**AGENDA
TECHNICAL REVIEW COMMITTEE (TRC)
September 2, 2025
10:00AM**

**MINUTES
TECHNICAL REVIEW COMMITTEE (TRC)
August 5, 2025
10:00AM**

**DEVELOPMENT REVIEW LETTER
FRUITLAND PARK SINGLE FAMILY
VARIANCE
8/14/2025**

CITY OF FRUITLAND PARK
STAFF REPORT BY LPG URBAN & REGIONAL PLANNERS, LLC.

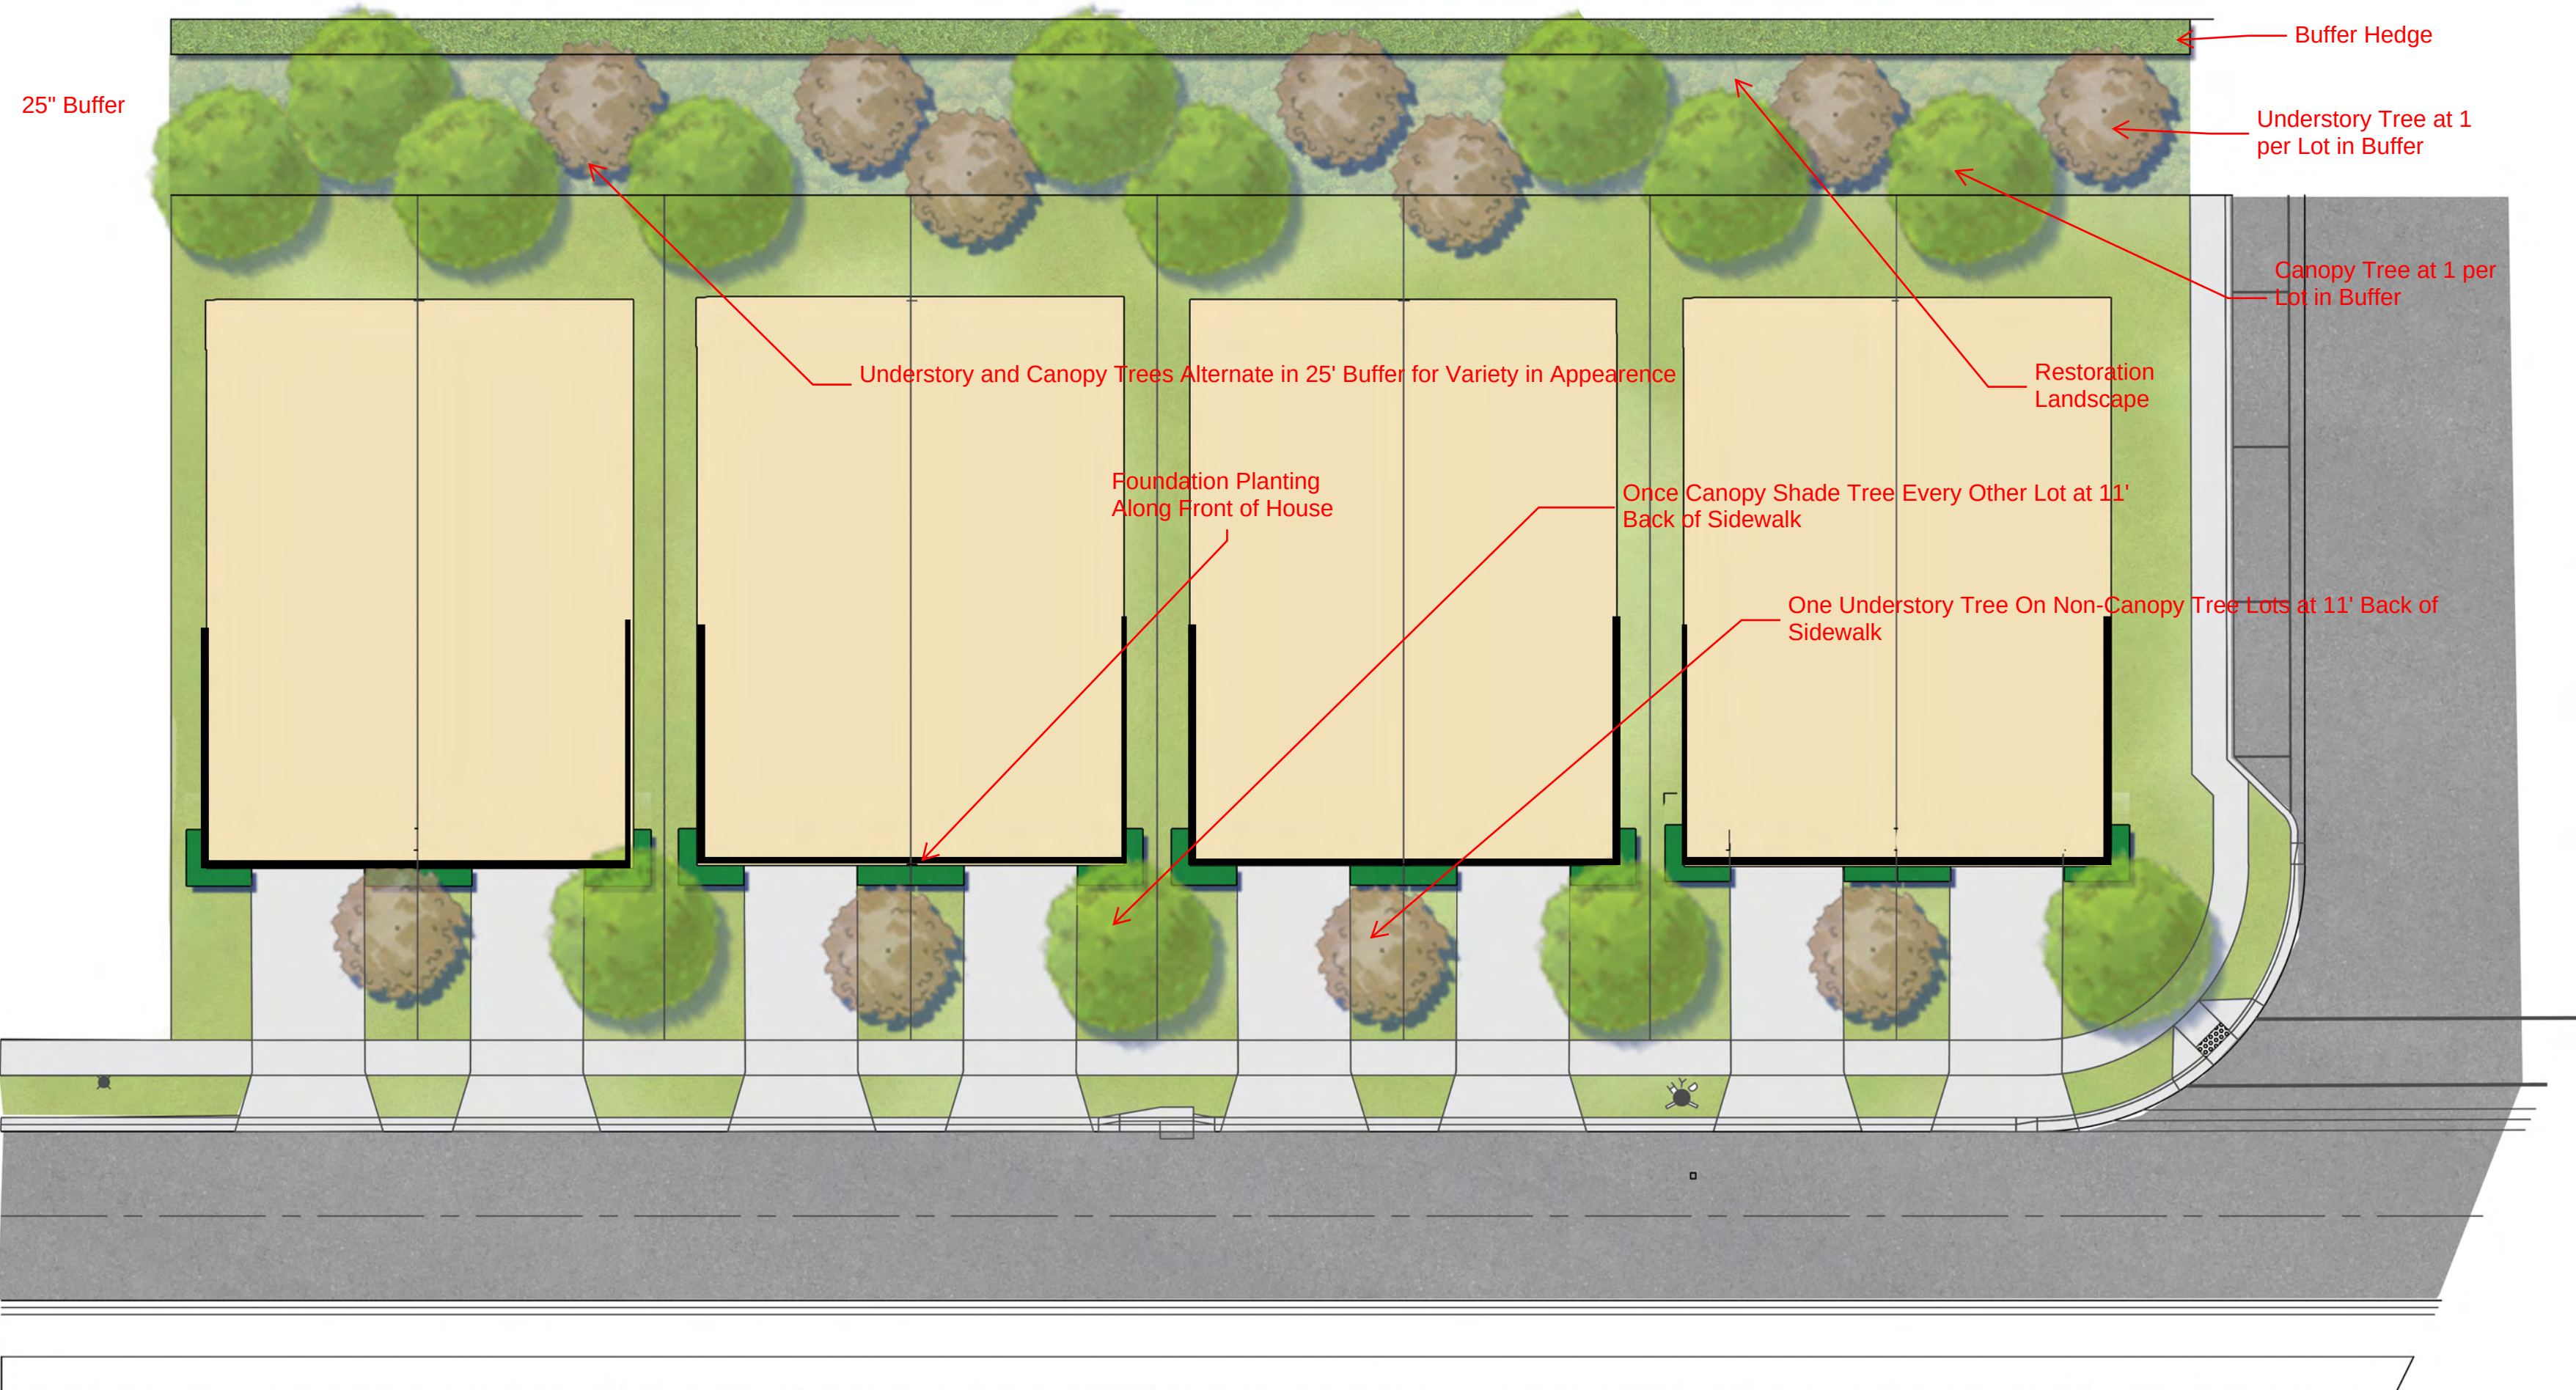
The justification for the variance is that the code is not clear if the Maximum Building Coverage applies to Planned Unit Developments. The Maximum building coverage is shown in the various residential codes. The proposed project plans to promote single-family one-story units and to permit variation in the various sizes. Based on the setbacks, the maximum building coverage would be 55%.

TYPICAL LOT LANDSCAPE TREATMENT
(50'X114')

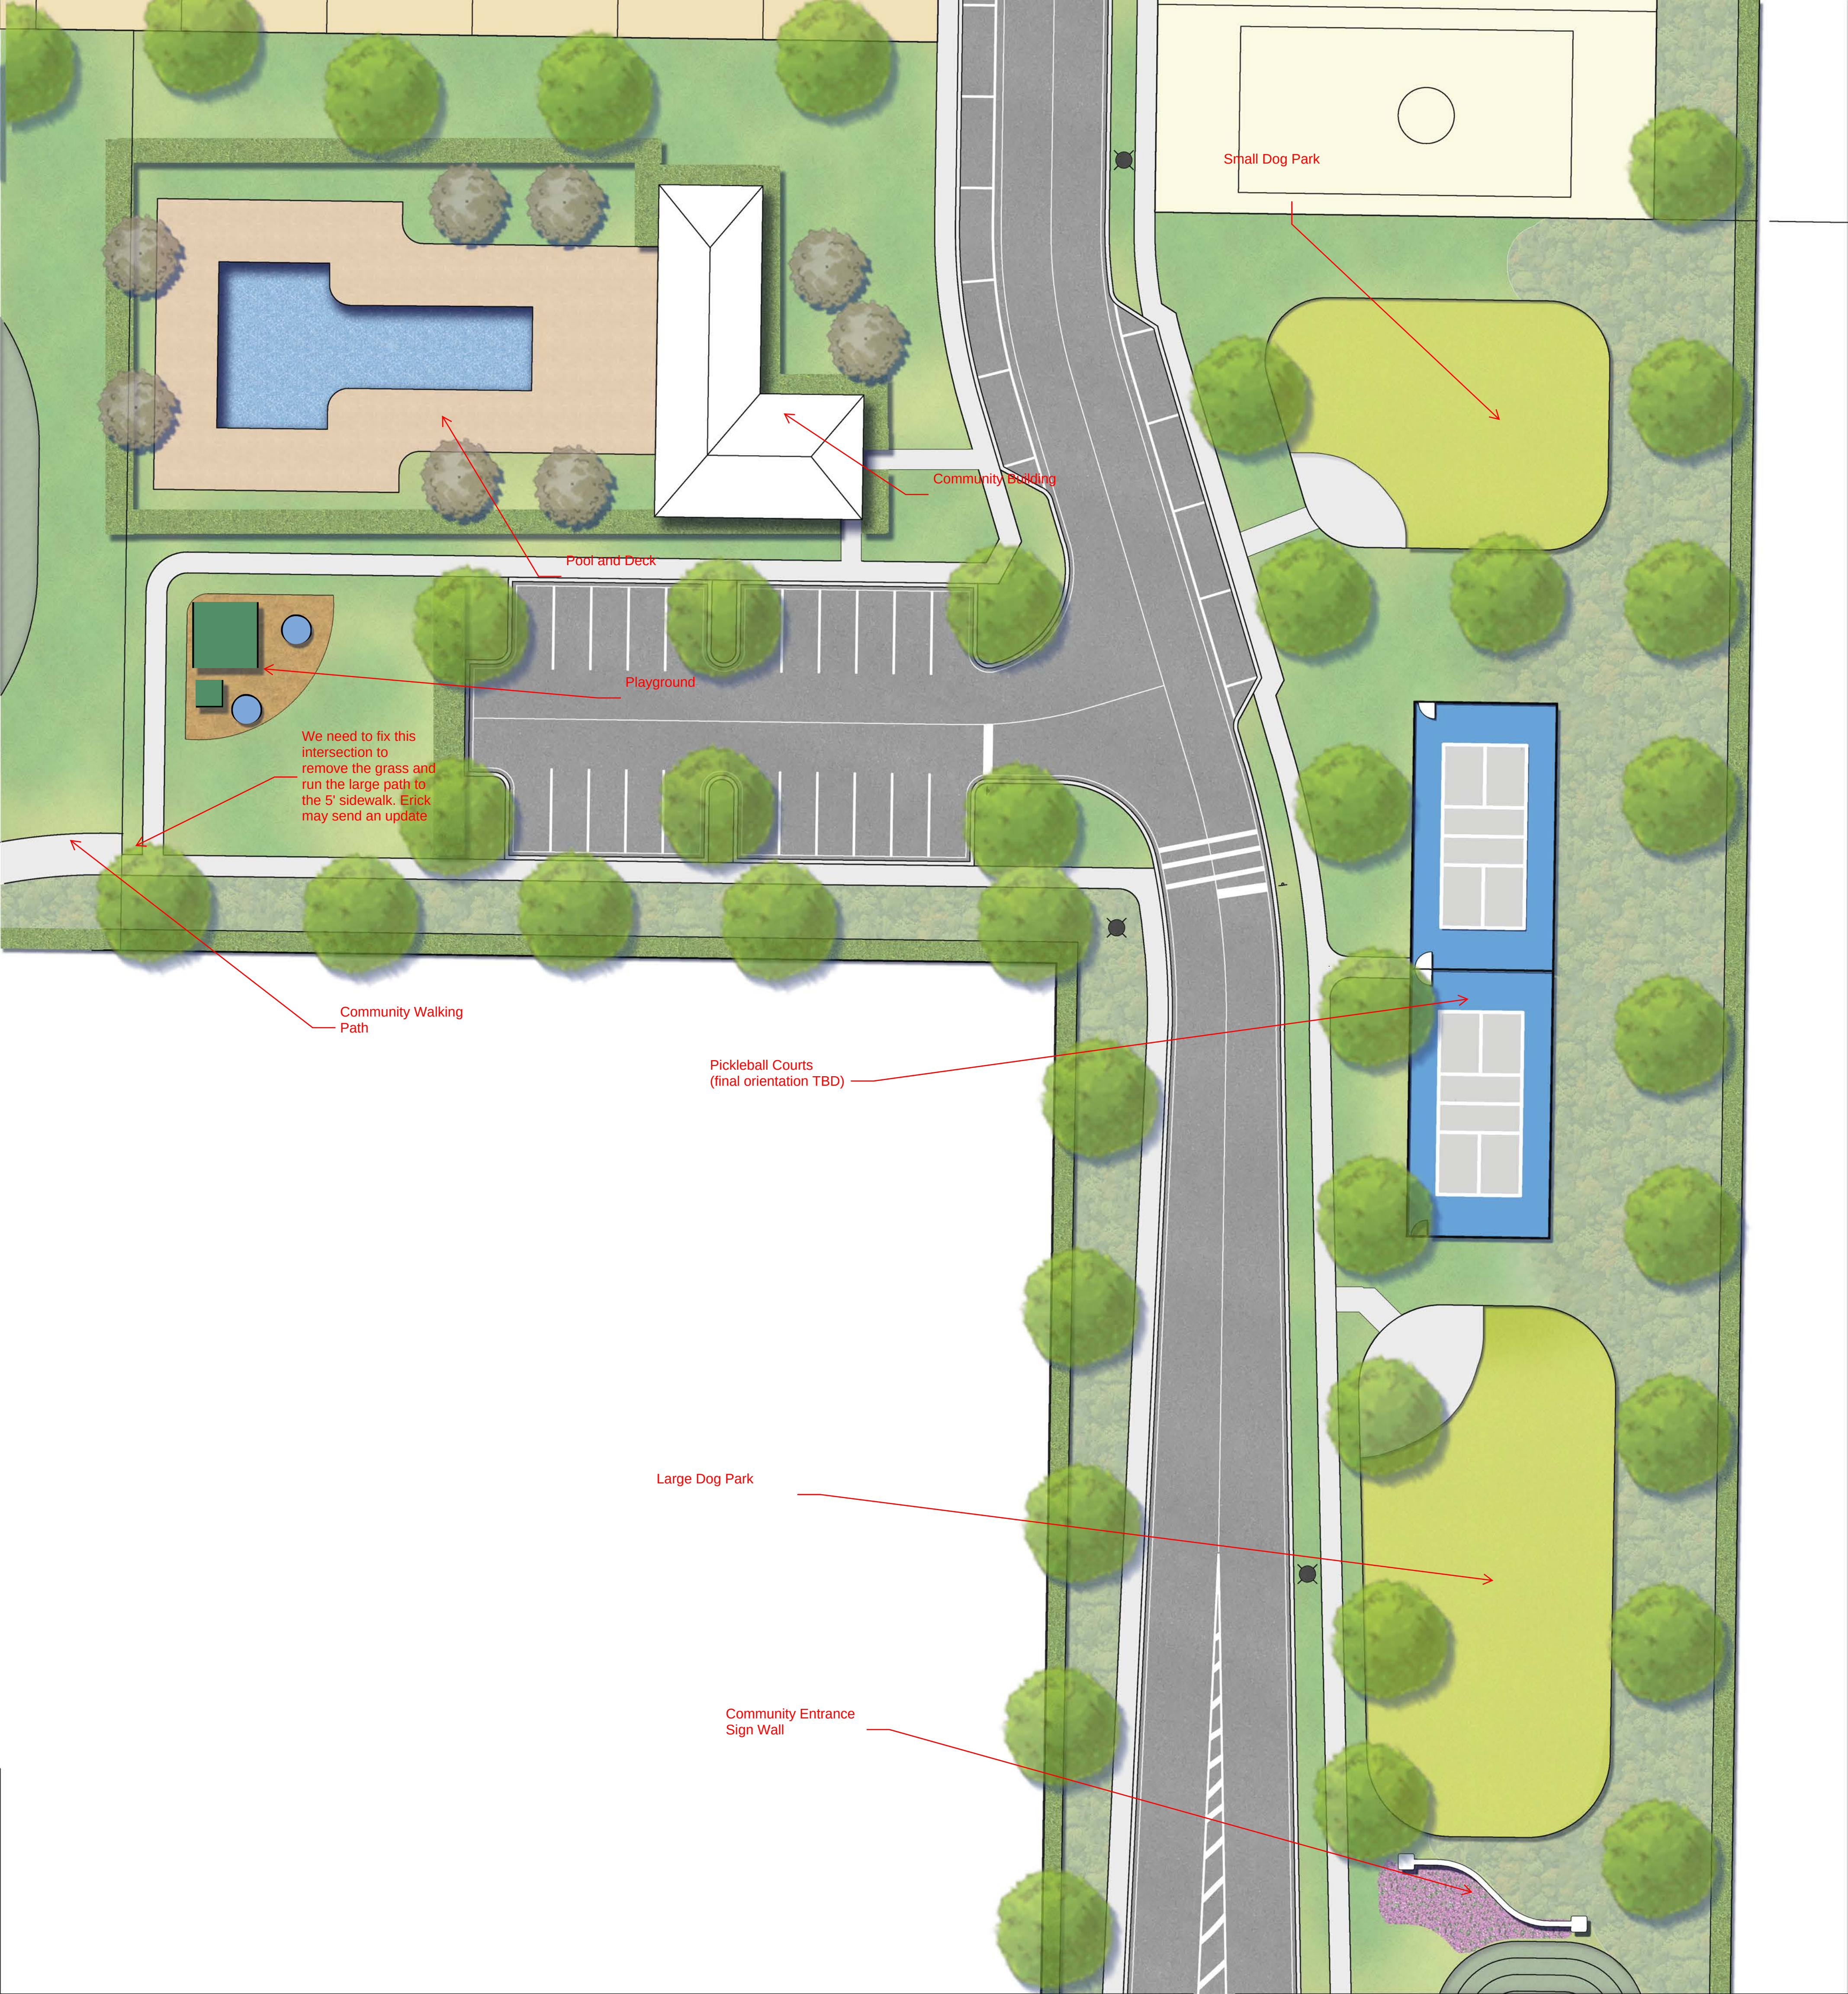
We need to fix this intersection to remove the grass and run the large path to the 5' sidewalk. Erick may send an update
